Metrolinx Lakeshore East Corridor
Community Advisory Committee RFP Meeting
Monday, October 29, 2018
Metrolinx
20 Bay St., Toronto, ON
9:00a.m. – 11:00a.m.

Metrolinx Response to the LSE CAC’s List for Inclusion in the Lakeshore East Corridor Expansion Project

**Comments and Recommendations from CAC to be included in the RFP(s) for
the Metrolinx Lakeshore East Corridor Expansion Project
Submitted by the CAC September 15, 2018**

5. Old Riverdale Neighbourhood

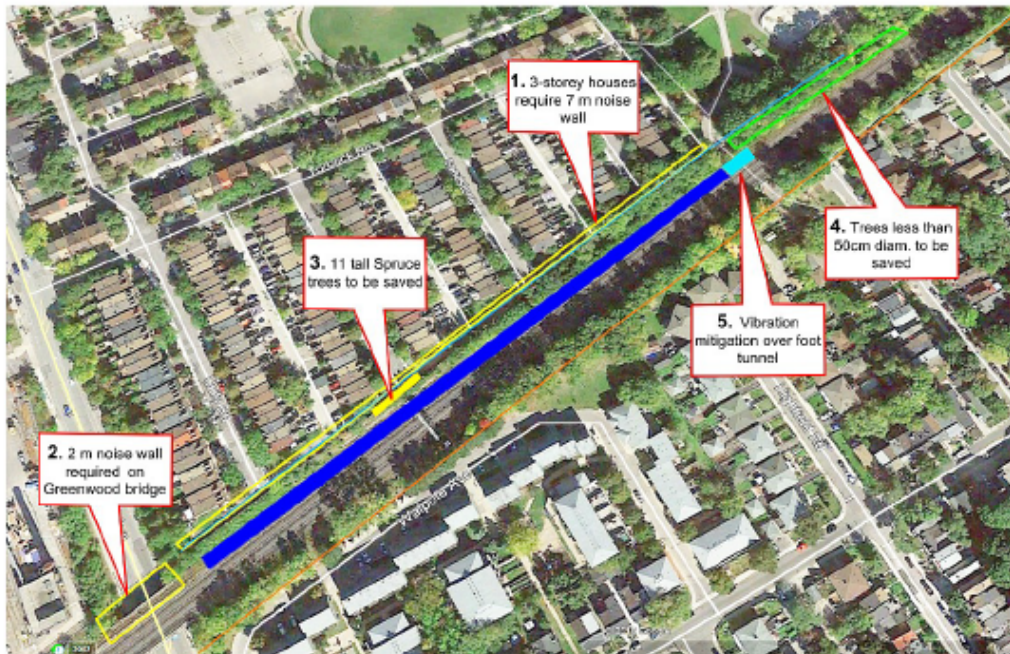
- 5.1 A large number of houses within 30 m of the tracks are three storeys high. To provide adequate sound mitigation for the master bedrooms located on the third floor, a sound wall 7 metres in height is required.

- 5.2 To protect the rear side of houses along the west side of Unity Rd., including decks and back yards, a 2 metre noise wall is required across the Greenwood Avenue bridge.
- 5.3 Eleven tall Spruce trees, planted at the foot of Lount Street to obscure the view of the Metrolinx signal bridge installed at that location, must be saved to preserve their original purpose.
- 5.4 Smaller trees on the Metrolinx right-of-way immediately south of Monarch Park must be saved to preserve the size and viability of the wooded habitat at the south end of the park.
- 5.5 Vibration mitigation is required over the foot tunnel located at the south-west corner of Monarch Park (noise wall already provided for).

<p>5. Old Riverdale Neighbourhood</p> <p>5.1 A large number of houses within 30 m of the tracks are three storeys high. To provide adequate sound mitigation for the master bedrooms located on the third floor, a sound wall 7 metres in height is required.</p>	<ul style="list-style-type: none"> Noise and vibration mitigation, where technically, economically and administratively feasible will be confirmed and considered for Pkg. 3*
<p>5.2 To protect the rear side of houses along the west side of Unity Rd., including decks and back yards, a 2 metre noise wall is required across the Greenwood Avenue bridge.</p>	<ul style="list-style-type: none"> Please refer to response above (5.1). In general, noise mitigation will not be installed on bridges due to structural loading requirements.
<p>5.3 Eleven tall Spruce trees, planted at the foot of Lount Street to obscure the view of the Metrolinx signal bridge installed at that location, must be saved to preserve their original purpose.</p>	<ul style="list-style-type: none"> An Arborist Report is currently underway. Only those trees/vegetation required to accommodate the grading works will be removed.
